ROGERS PLANNING COMMISSION AGENDA

Date:	February 1, 2022
Location:	301 W. Chestnut Street/Virtual (Zoom)
Committee Sessions:	4:30 PM
Regular Session:	5:00 PM

RE: **STAFF SUMMARY REPORT**
LARGE-SCALE DEVELOPMENT PLANS – THE GROVE RESIDENTIAL COMMUNITY

Re: Conditional Approval of Civil Plans
Grove 2021

OVERALL PHASING PLAN

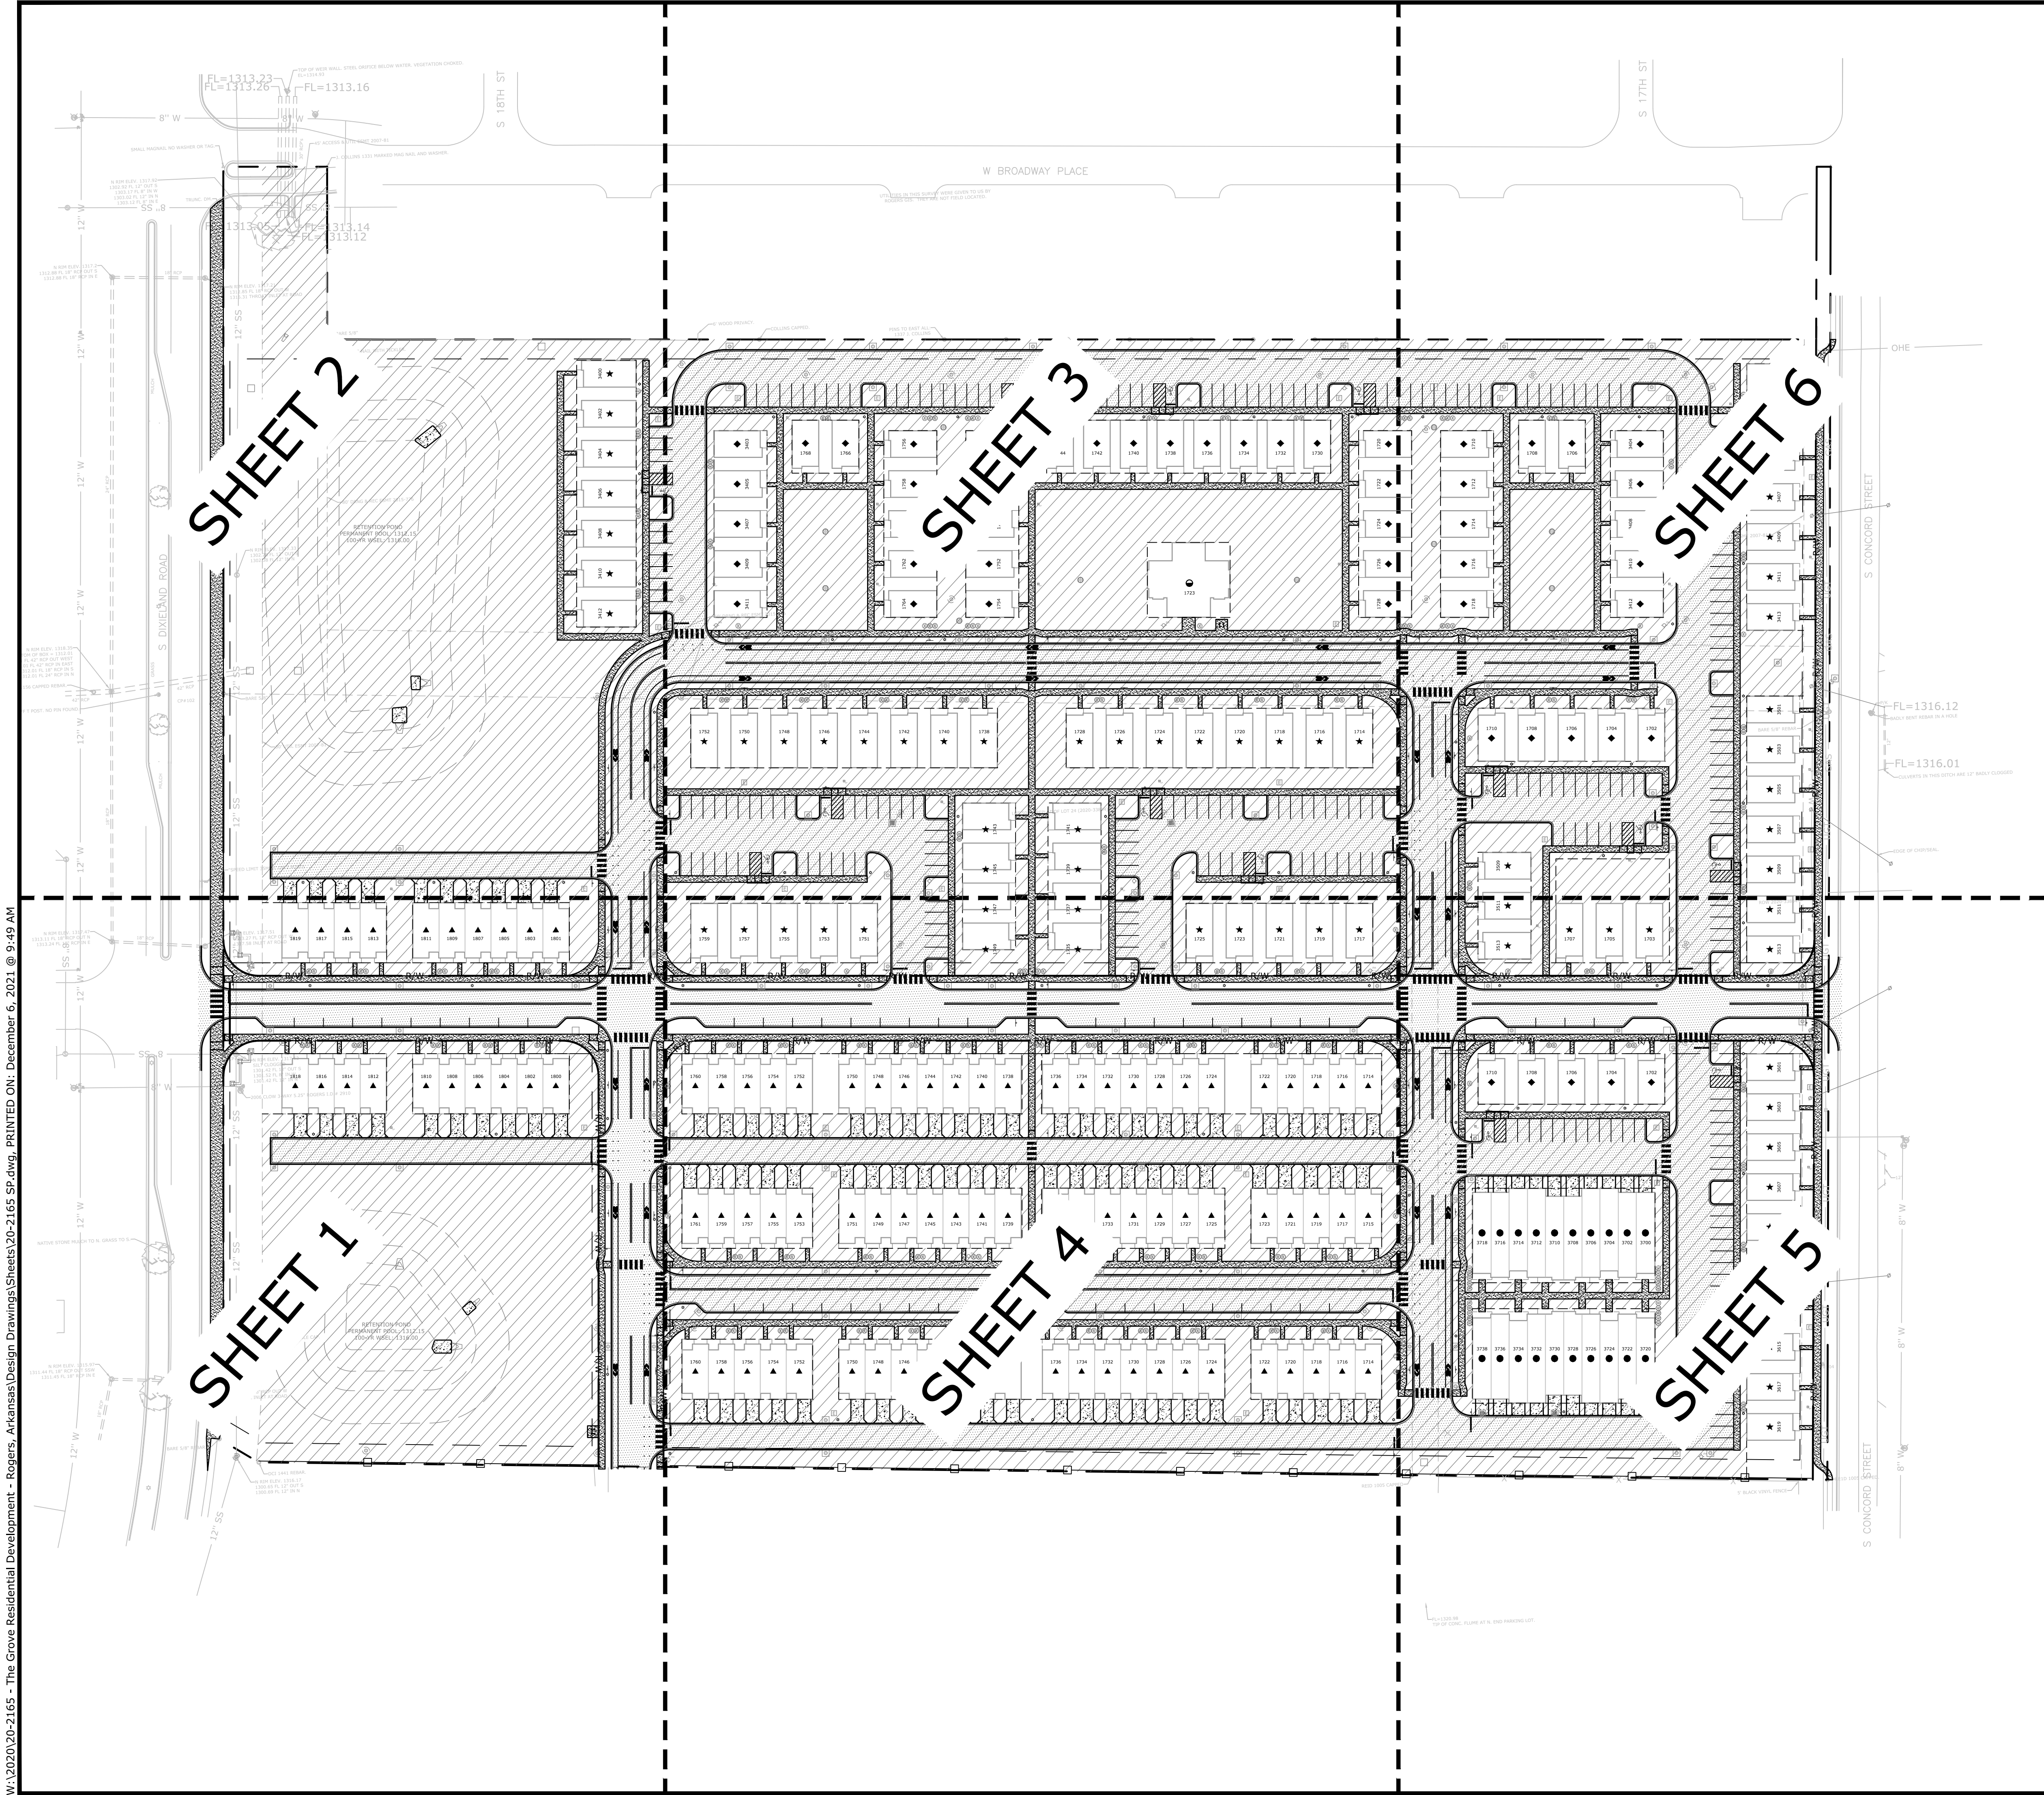
The applicant requests a **WAIVER** from Section 14-604(c)(2) from requiring a north/south connection every 660-feet. The applicant shows a southern connection approximately 286-feet from the S Dixieland Road right-of-way to the west, being approximately 895-feet from the S Concord Street right-of-way to the east, which exceeds the maximum allowable 660-feet. The applicant's waiver request states *"MCE has gone through two DCP processes, along with Large Scale Development with the proposed street in its currently shown location, and was reviewed/approved each time without comment regarding the southern stub out connection location."* This is not accurate in that the following was provided in the Staff Report during the December 7, 2021 DCP approval:

REQUEST to ALLOW: Request to allow proposed public street and future stub to remain in current designed location as it has been represented through two approved Density Concept Plans (Ordinance 21-33 dated 4/13/2021 & Ordinance 21-82 dated 12/14/2021) as well as receiving conditional approval through Large Scale Development city review on 1/10/2022. DCP layouts (with ordinances) and current site plan with conditional approval attached for reference. Rogers Code Section 14-604c

MCE has gone through two DCP processes, along with Large Scale Development with the proposed street in it's currently shown location, and was reviewed/approved each time without comment regarding the southern stub out connection location. Additionally, the 660' measurement is taken from S. Dixieland Rd. along unnamed private east-west road approx. 400' south of The Grove property with the final location of the drive stub directed toward property that is not owned by our client, nor is that property part of the current development plan. Future development of the parcel directly south of the proposed development can be designed to adhere to the 660' requirement along its adjacent unnamed private road to its south.

OVERALL
UTILITY PLAN

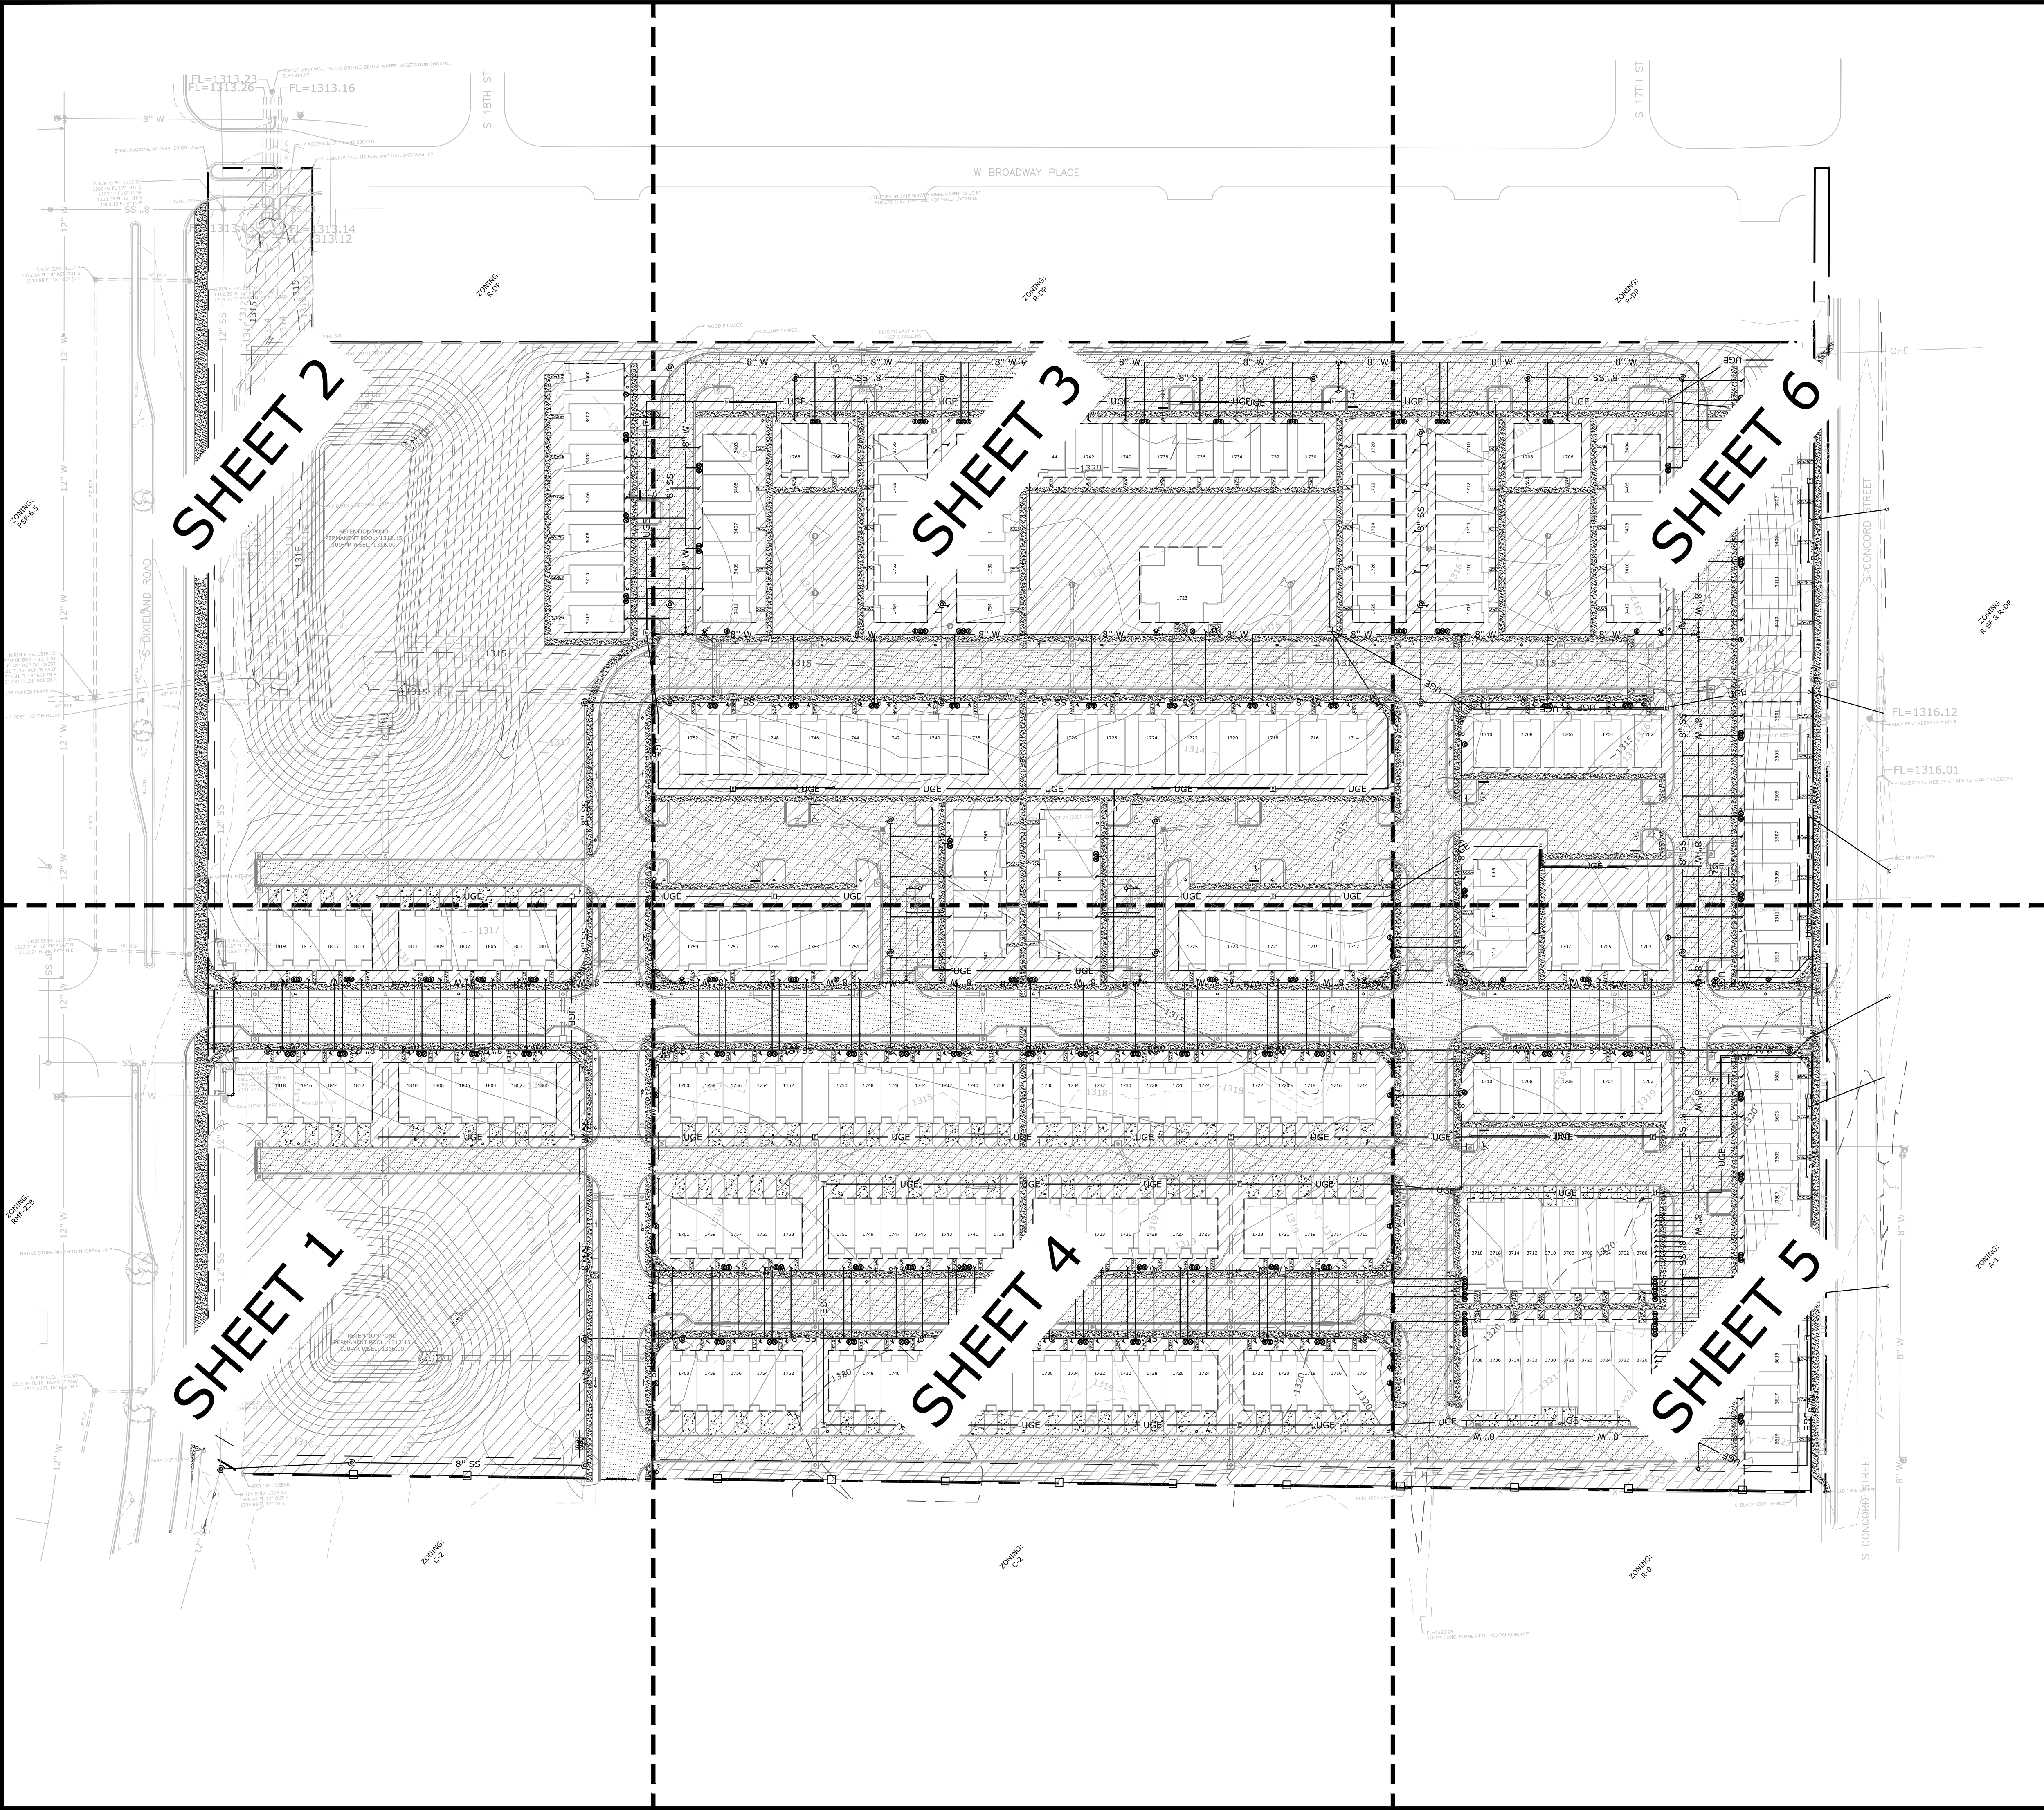
1. The following items are necessary plan revisions, and our redlined plans are attached for further clarity:
 - a. Revise General Utility Notes and Legends as follows on Utility Plan Sheets 1-6:

- i. Remove Note 1 (Material specifications are included in RWU Standard Specifications & Details).
 - ii. On Note 8, refer to the "latest revision" of the RWU Standard Specifications & Details.

- iii. Remove Note #29 (RWU no longer specifies a heavy-duty lid).
 - iv. On the Proposed Legend and Utility Details on Utility Plans, clarify proposed meter sizes and whether 5/8" meters are single or double sets.

- c. Waterlines should be located above storm drains wherever possible. The redlined plans note locations where it appears adjustments can be made to accommodate this requirement by one or more of the following acceptable methods:

- e. Provide one of the two following flushing options for the waterline at each phase line:
 - i. Hydrant tee with plugged valve for connection to future phase.

- ii. Inline valve (restrained with anchor collar) with temporary hydrant
 - f. Provide a separate plan & profile for any hydrant stub longer than 20' (see Water Main C).

- i. On Sewer Main "H", reduce the number of sewer taps at the main by providing a common private drain line for each row of townhomes. Coordinate plans with MEP to ensure adequate separation between water/sewer services, and ensure that any shared drain line is noted as a common element of the development in the governing documents for the development.

- j. Add the following annotation at appropriate locations on water & sewer profiles:
 - i. At trench backfill locations beneath public roadways: "Provide full depth aggregate base backfill, compacted."
